TENNESSEE VALLEY AUTHORITY

January 12, 1984

Enclosed for NRC review is information concerning TVA activities at Watts Bar Nuclear Plant related to the issue of liquefaction potential. Enclosure 1 provides TVA responses to NRC and Corps of Engineer concerns about slope stability. Enclosure 2 provides amended FSAR material which reflect remedial action. Enclosure 3 provides a report entitled "Site-Specific Top-of-Ground Motion for ERCW Pipeline with Response to the NRC Staff Concerns." This report dated September 23, 1983 was prepared for TVA by Woodward-Clyde Consultants.

AMENDED FSAR MATERIAL WITH DESCRIPTION OF
TVA REMEDIAL ACTION FOR POTENTIAL LIQUEFACTION

FIGURE 1

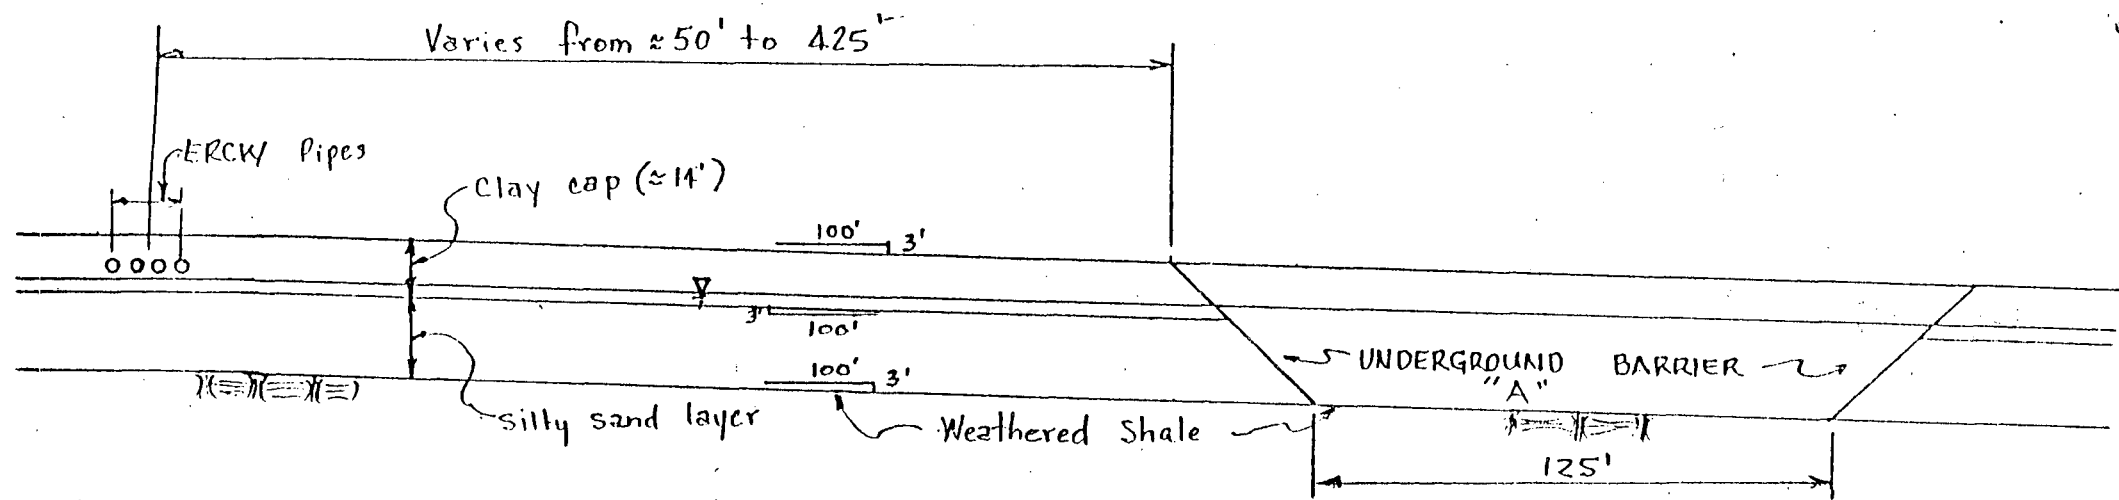
Question 1:

There is a large distance, covered by the future 161 kV switchyard, between the ERCW piping and trench. Has the stability of this area been checked for a seismic event?

The area designated as the future 161 kV switchyard has been regraded as shown on proposed figure 2.5-584 of the FSAR. The grade (slope) of this area is very gentle (between 1 and 2 degrees). The soil profile is fairly consistent between trench A and the ERCW piping. A clay cap approximately 14 feet thick overlays a silty sand layer. A typical cross section is shown in figure 1. The stability of this area was checked using the block and wedge method of analysis with the same soil strengths used in the underground barrier analysis as discussed in section 2.5.5.2.3 of the FSAR. The pseudo-static analysis performed for the underground barrier assumed zero shear strength (i.e., complete liquefaction) for the silty sand layer and a peak acceleration occurring simultaneously. This method is very conservative and has limits on its appropriateness. The most conservative assumption is to assume the total mass has a constant acceleration in the direction of instability. An earthquake motion is cyclic in nature in that the earthquake load randomly changes direction during an earthquake. Another conservative assumption is to assume complete soil liquefaction occurs prior to or in conjunction with the peak acceleration. This assumption was used in the barrier analysis to achieve the most conservative (highest) earth pressure in conjunction with the peak acceleration for determining the barrier width.

Because (1) the area being considered is relatively flat (see figure 1), (2) the earthquake loads are cyclic (i.e., not constant in the direction of instability), and (3) the potential soil liquefaction will not occur until after the peak acceleration, the most appropriate case to examine for the area between trench A and the ERCW piping is the postearthquake situation assuming complete liquefaction of the silty sand layer. The factor of safety for this case is 1.7. The factor of safety for the area prior to an earthquake is 12.6. Based on these analyses, it is concluded that these slopes are stable.
